**From:** Geoff Slattery [g\_slattery@bigpond.com]  
**Sent:** Tuesday, 30 April 2013 3:03 PM  
**To:** 'sue.stewart@chcc.nsw.gov.au'  
**Subject:** Lyons Road  
**Attachments:** chcc 300413 sue stewart.pdf

**SUBDIVISION LOT 112 DP 1073781  
LYONS ROAD, NORTH BONVILLE  
DEPARTMENT OF PLANNING MAJOR PROJECT M808-0080**

**From:** Sue Stewart [sue.stewart@chcc.nsw.gov.au]  
**Sent:** Monday, 13 May 2013 9:51 AM  
**To:** 'Geoff Slattery'  
**Cc:** Mark Hannon; Tim Cotsell  
**Subject:** Proposed subdivision lot 112 1073781

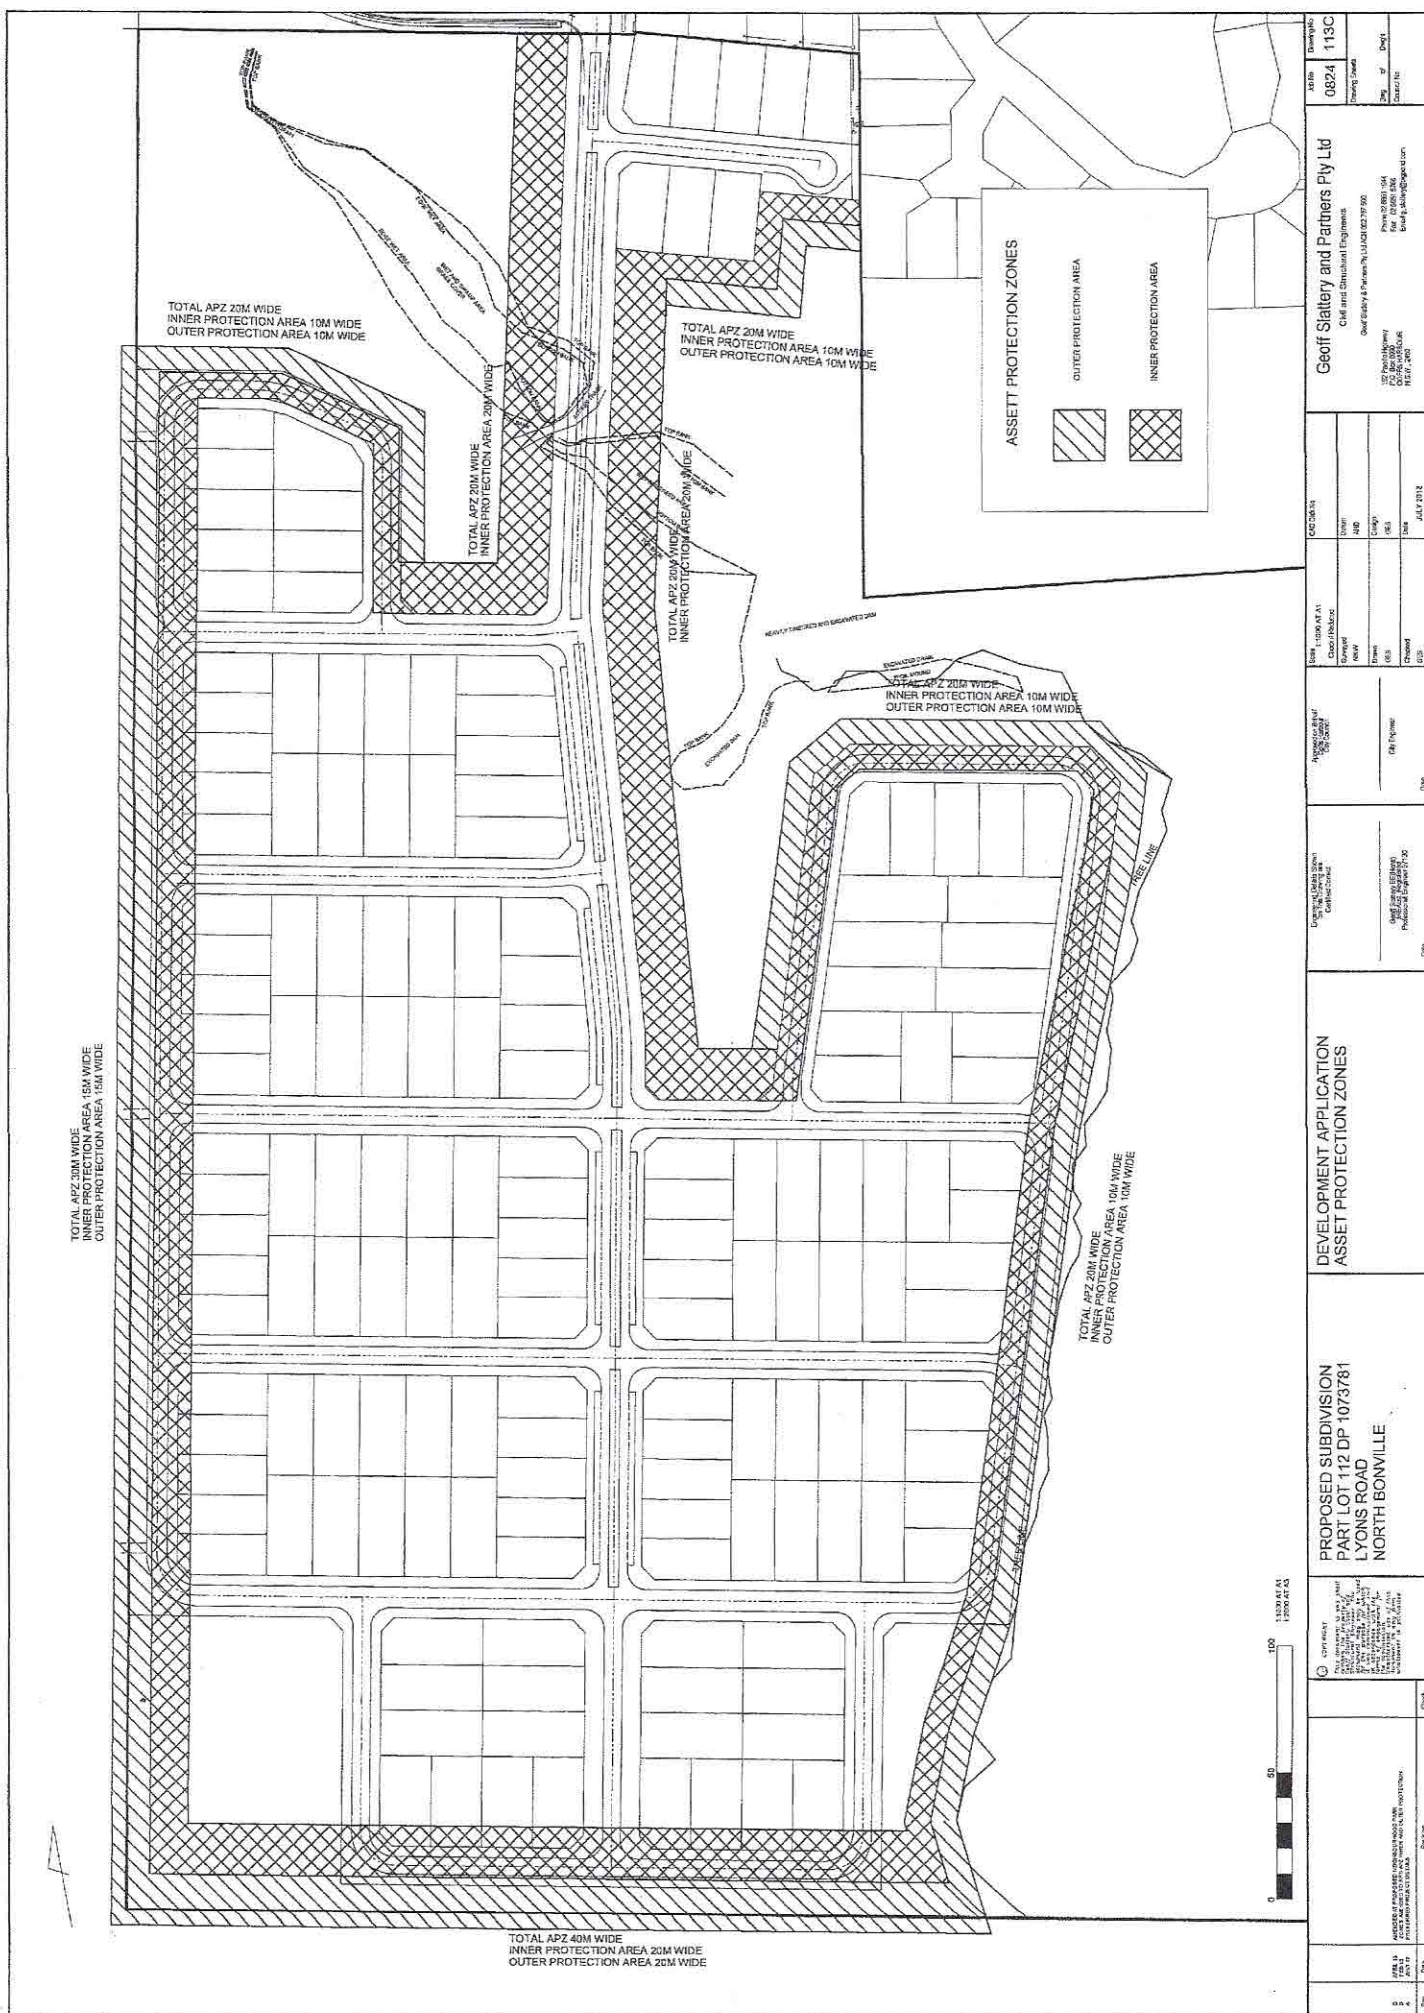
- The topsoil material containing artefacts that is proposed to be relocated is placed in the future public reserve on the eastern side of the collector road (as indicated in plan xxx). Details of location to be confirmed at CC;

Topsoil can be placed in proposed Public Reserve located on the East side of the entry road. Refer Drawing 121.

The proposed topsoil areas are located such that there will be no foreseeable disturbance, and the area will be subject to replanting as part of the VMP.

Estimated volume of topsoil is expected to be a maximum of 6600 cubic metres based on the area indicated on attached drawing which is from the Archeology report

In the relocation areas the average depth is say 450mm, but will vary as anticipated fill depth could be as high as say 800 to 1000 depth when the bulk earthworks are designed for the CC

The intention would be to locate the topsoil into as small an area as possible, so in the final CC I would expect we would not use the total area nominated

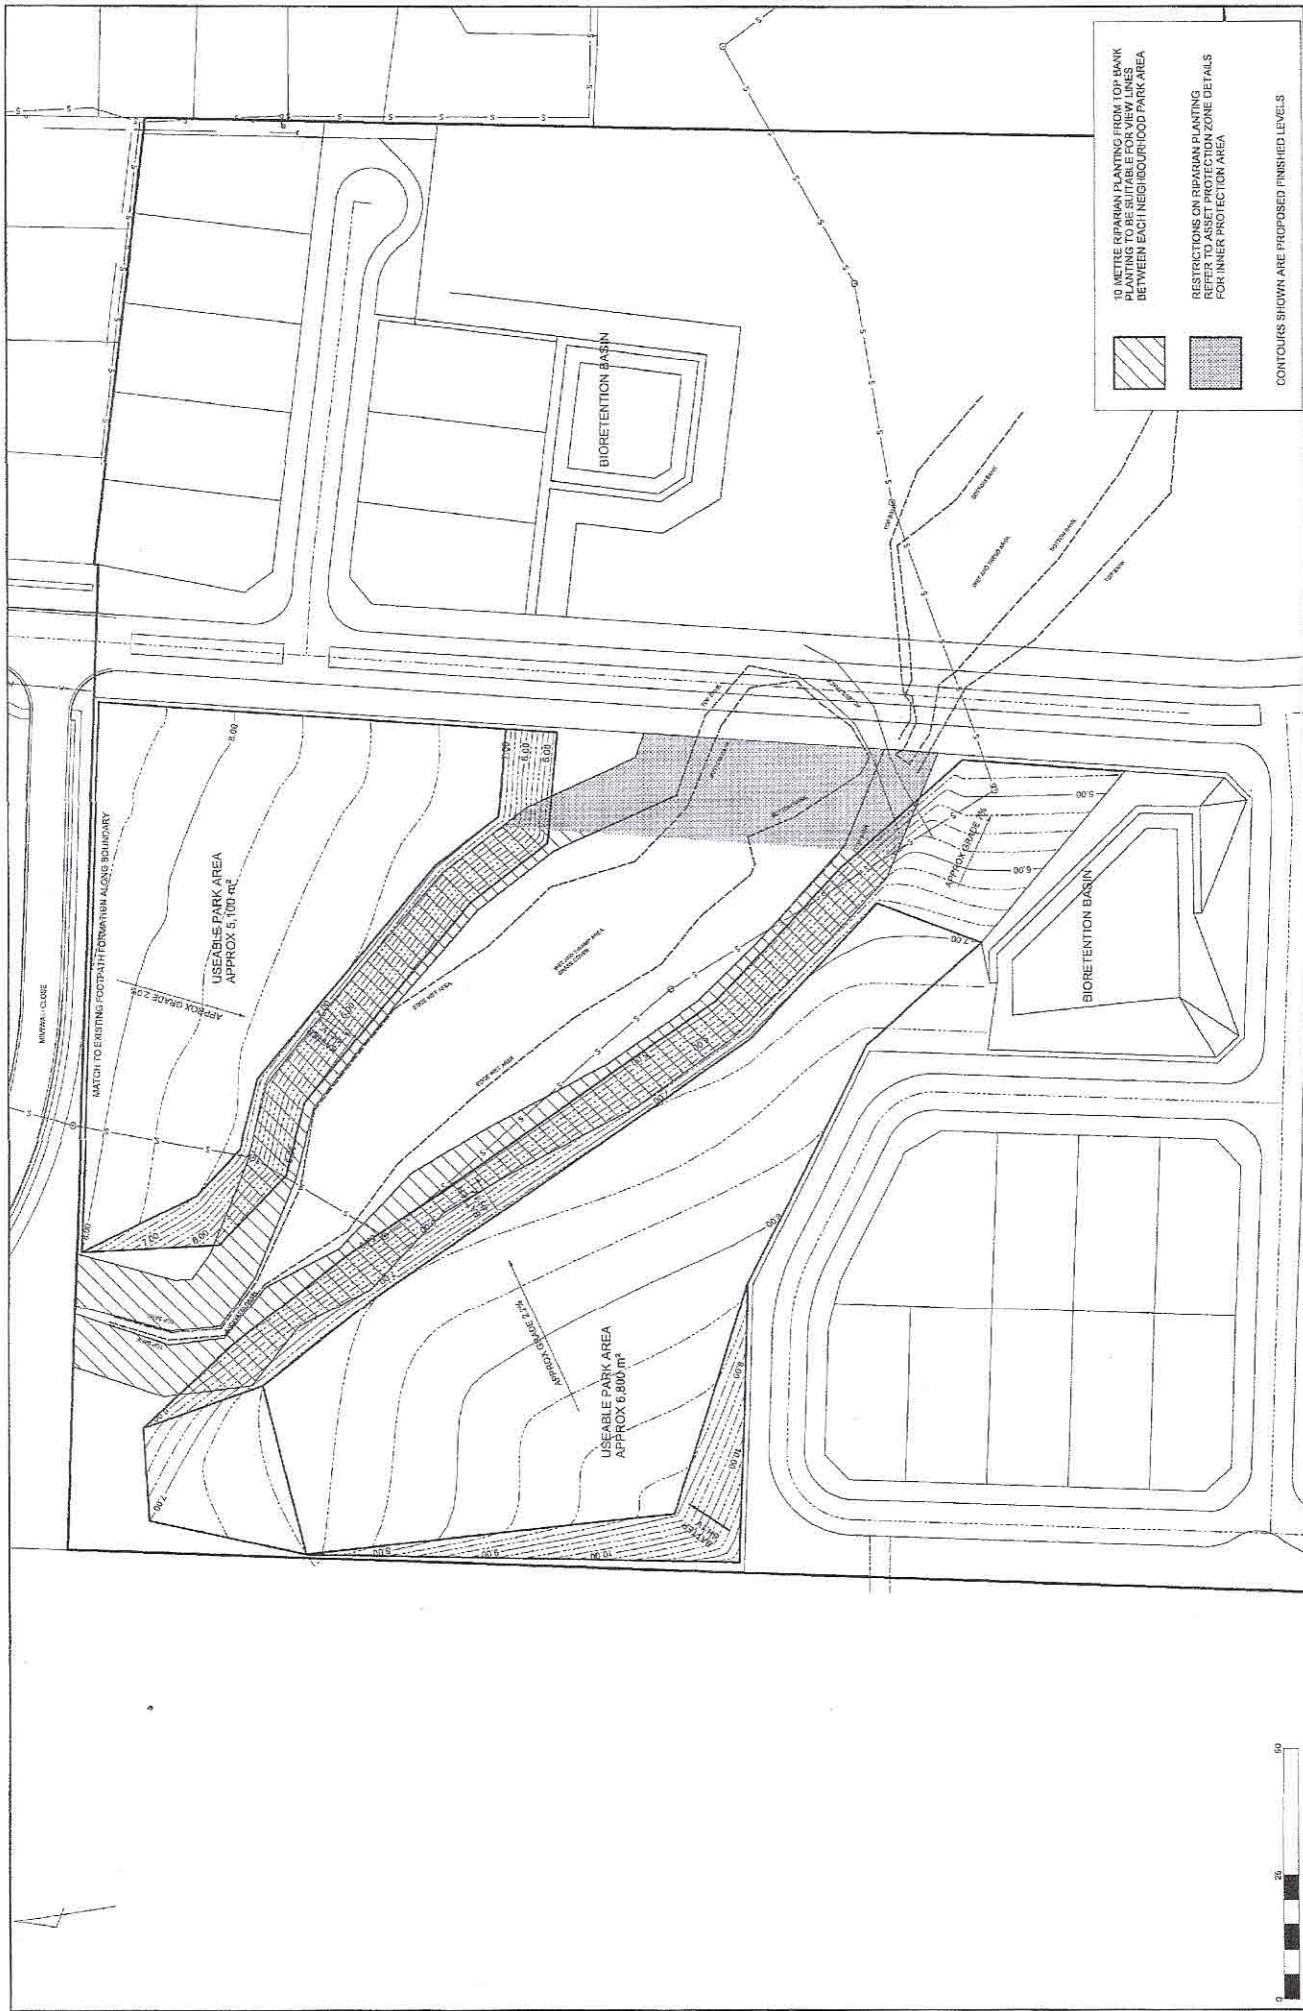
Council is satisfied with the public preserve proposed on the western side of the collector road subject to the following:

- The VMP is modified such that all planting within the relocated topsoil are established as part of the initial works;
- The VMP is modified to reflect that planting of the riparian area ( between the northern and southern areas of the proposed public reserve on the western side of the collector road) will be no greater than 10m's from top of bank and planted in a manner that enables surveillance and view lines to occur between the northern and southern sections of the proposed park (ie groundcovers and canopy trees only) batters of the creek in the reserve west of the collector road will be no greater than 1 in 4 to allow mowing if required.

- Proposed Park West of Collector road to be regraded such that approx 1 hectare of useable area is obtained
- Overland flow paths are to maintained and local drainage issues addressed in conjunction with fill placement

The proposed park area can be achieved in the area of proposed Public Reserve located on the West side of the entry road. Refer Drawing 120.

The area is split by the riparian area, however this is utilised to separate what is seen as "kick around" and "play" areas.

Useable area for the "kick around" is in the order of 6800 square metres.

Useable area for "play" is 5100 square metres.

The riparian area planting proposed is to suit your requests of suitable "view lines" through the planting
